Channel Stability Problems, Pajaro River, Watsonville and Pajaro, California

U.S. Army Engineer Committee on Channel Stabilization Report of the 63rd Meeting

ERDC/CHL SR-00-3
CCS-00-1
August 2000

Figure 6. Incorrect installation of erosion control mats

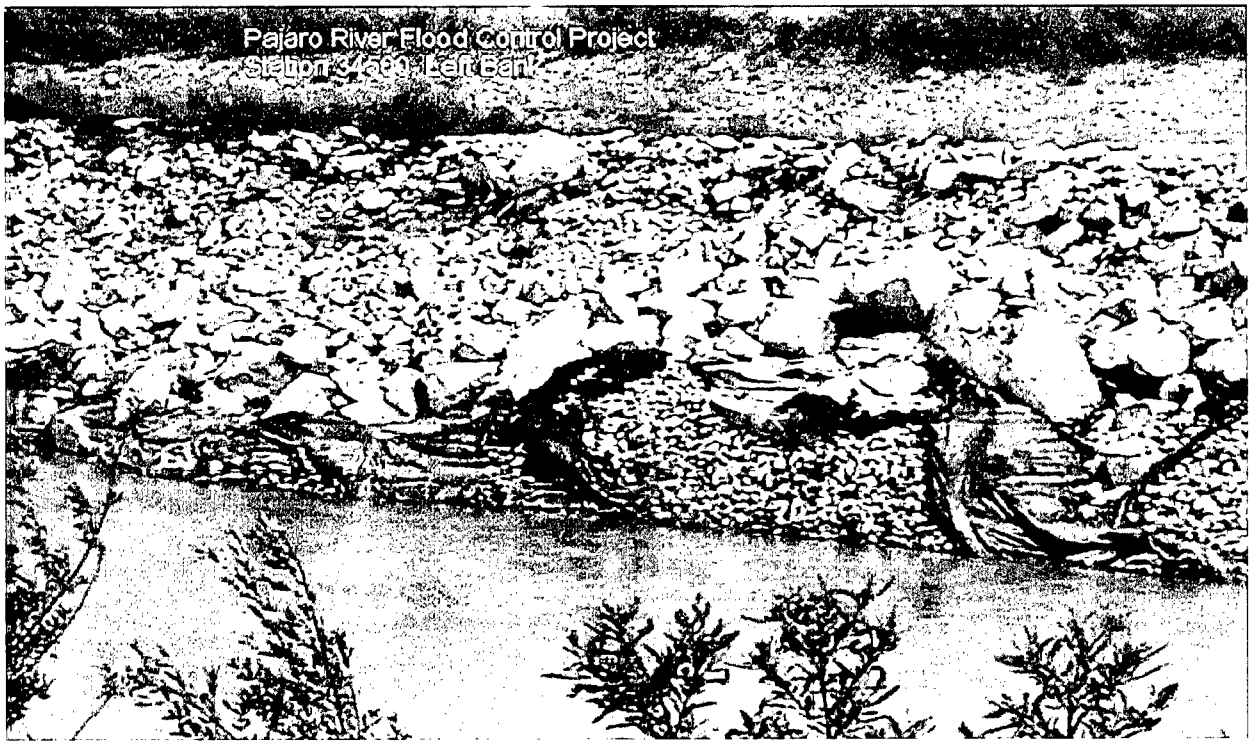
c. The locations where the banks have been stabilized are very steep. Also, the stone, although apparently well graded, is inconsistent in size. The erosion control mats have been installed incorrectly and/or have been applied to situations for which they were not intended (see Figure 6).
